# ADDENDUM No. 1

ITB No. 4689

## School Girls Glen Culvert Replacement – Nichols Drive

Addendum No. 1  
08/27/21

SHEET No.  
 4

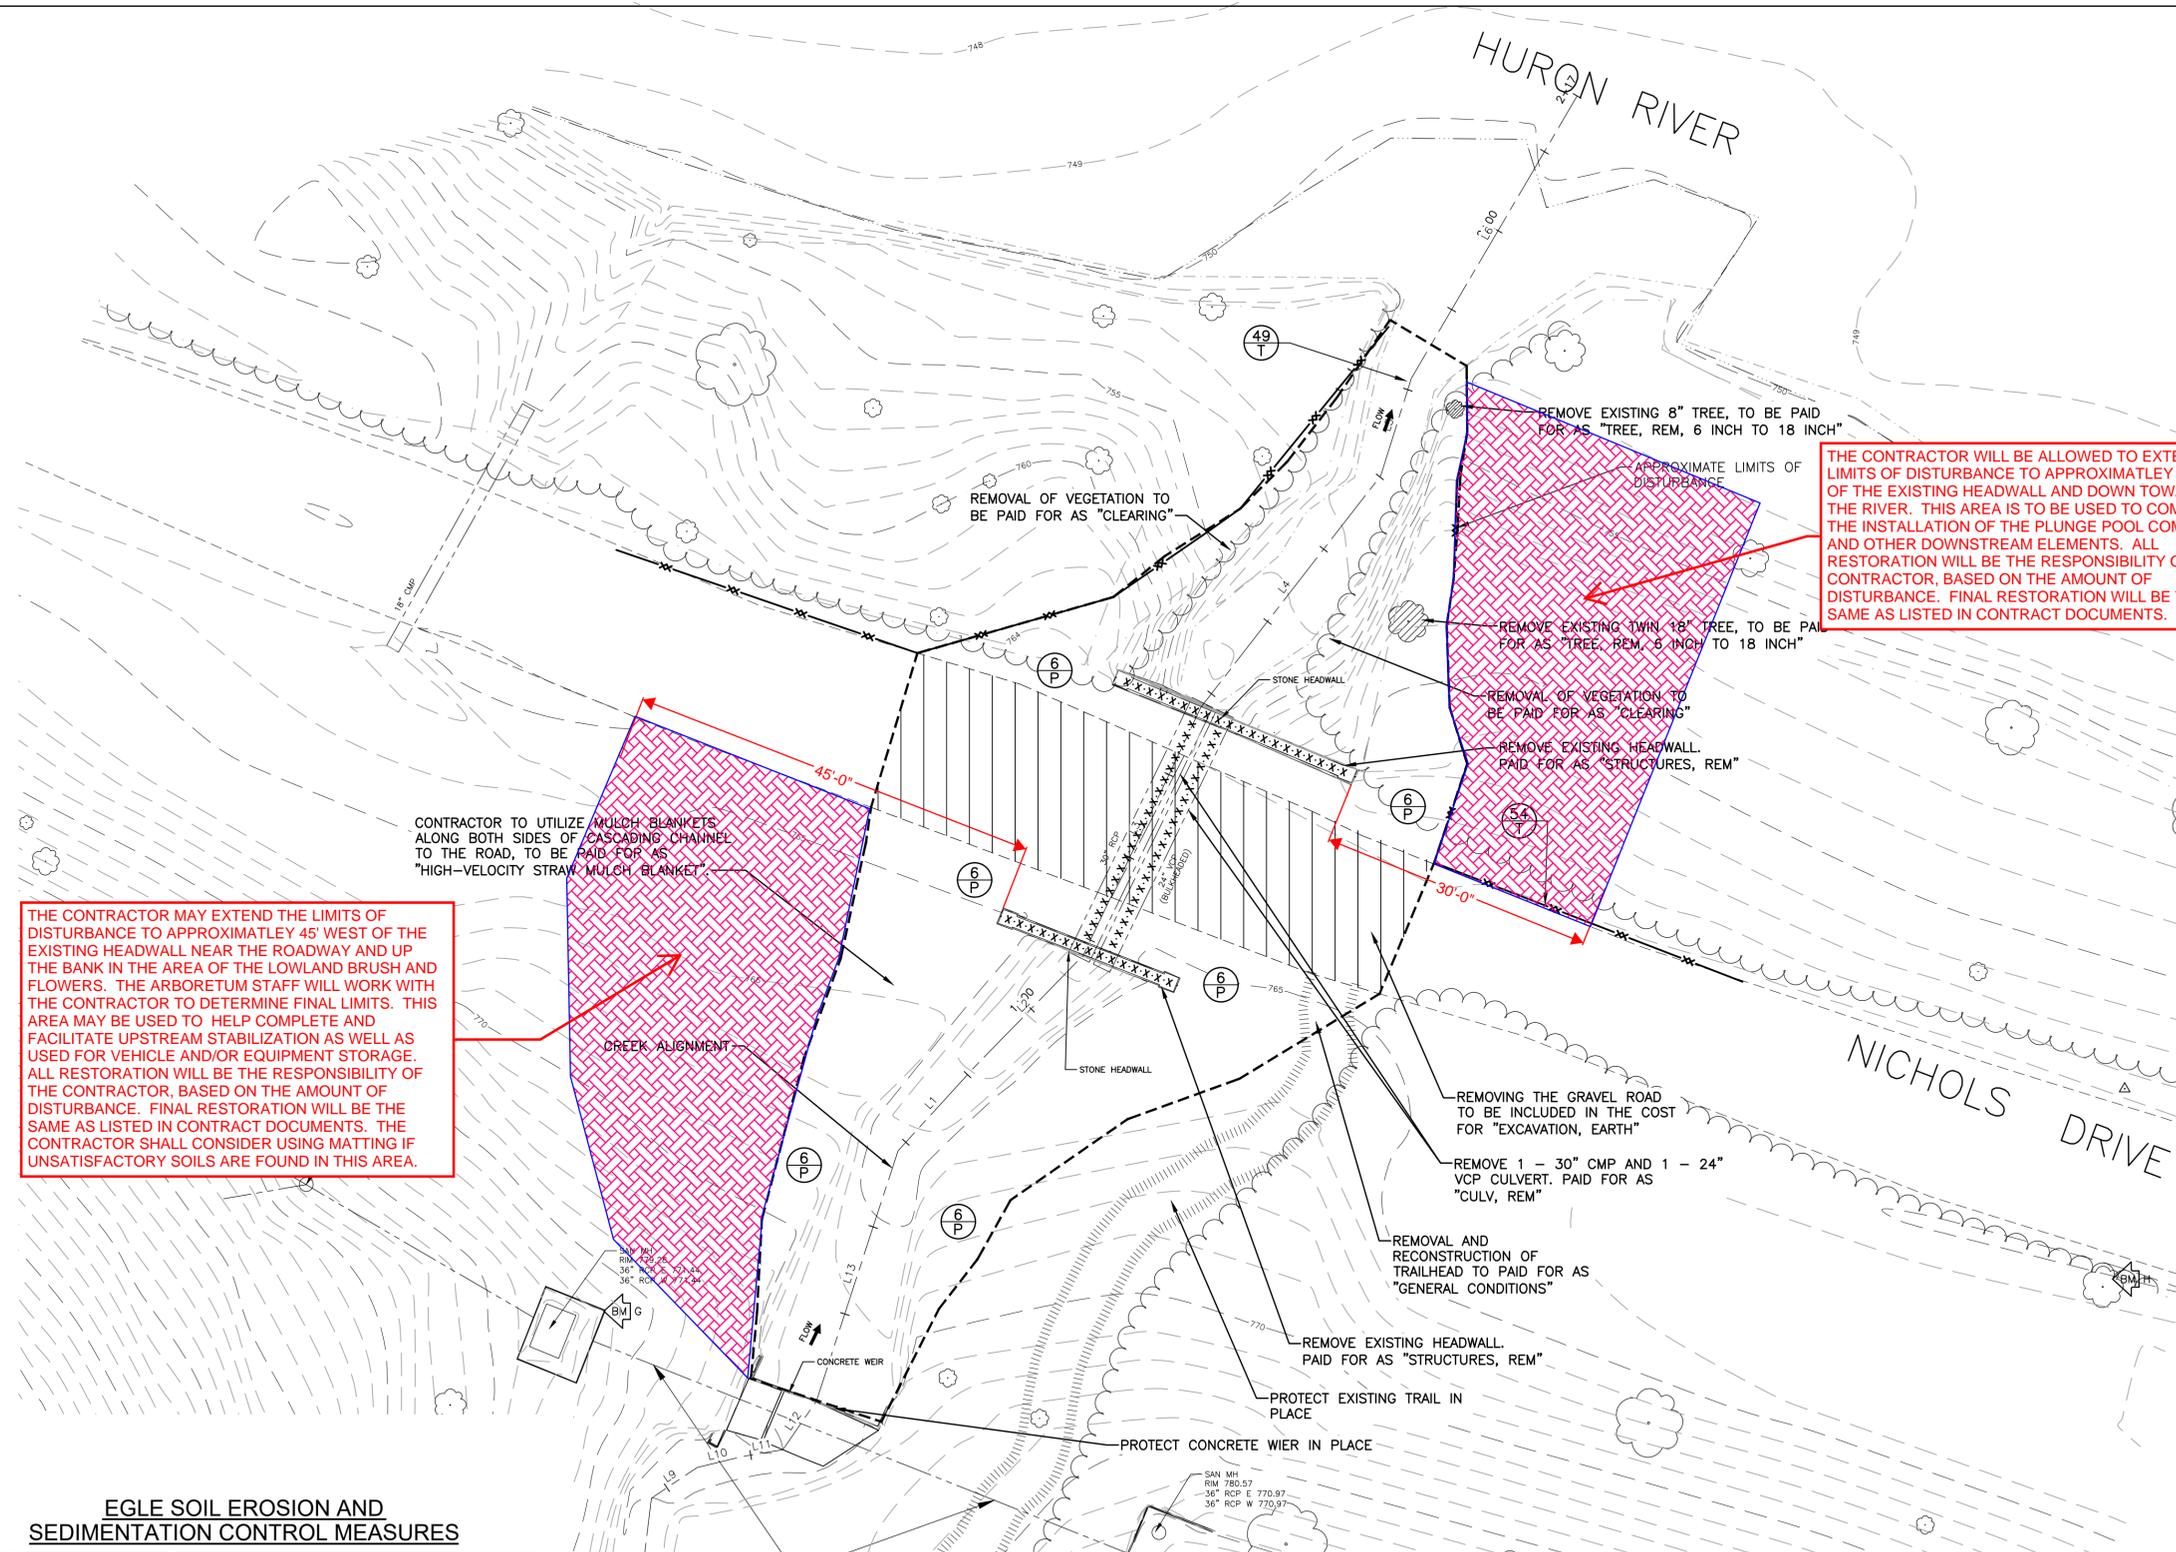
Section/Page(s)	Change
Bid Form – 2 pp	Remove and replace BF-1 and BF-2 with the attached Bid Form <ul style="list-style-type: none"><li>• Items changes on BF-2:<ul style="list-style-type: none"><li>○ REMOVE: Line Item #28 “Embankment, Structure, CIP” from the Bid Form, as this quantity of embankment is covered under the pay item for “Subgrade Undercutting, Modified”.</li><li>○ ADD: Line Item #40 “Arboretum Plantings, Reimbursement [Allowance]” with a Dollar allowance of \$5000. This item will covers the cost of any special plantings the Arboretum will require during restoration of the disturbed areas. Use of this item is by approval from the City ONLY.</li></ul></li></ul>
Plan Sheet Sketch (Pg. 4)	Review the sketch for the additional allowable areas of disturbance on the SW and NE quadrant of the culvert crossing. The Arboretum will allow the contractor to disturb, remove, and restore the plant life in the areas hatched out in “RED”. This area extends approximately

45 feet west from the west end of the southern headwall, and approximately 30 feet east from the east end of the existing northern headwall.

- The Contractor will be responsible for working with the City and Arboretum staff to determine the final limits of allowable disturbance. Within these limits, there could be plants or trees that need protecting and the Contractor will be responsible to avoid at all times.
- Storage of granular material in these areas are prohibited. The Contractor may store equipment, vehicles, or other material (non-granular) or may use this area to park their equipment when not in use.
- The Contractor will be responsible for restoring all areas with the same restoration as detailed in the plans (topsoil, seed, and mulch).Page 11 Remove: "These personnel must be a licensed physician, licensed psychologist or licensed psychiatrist."
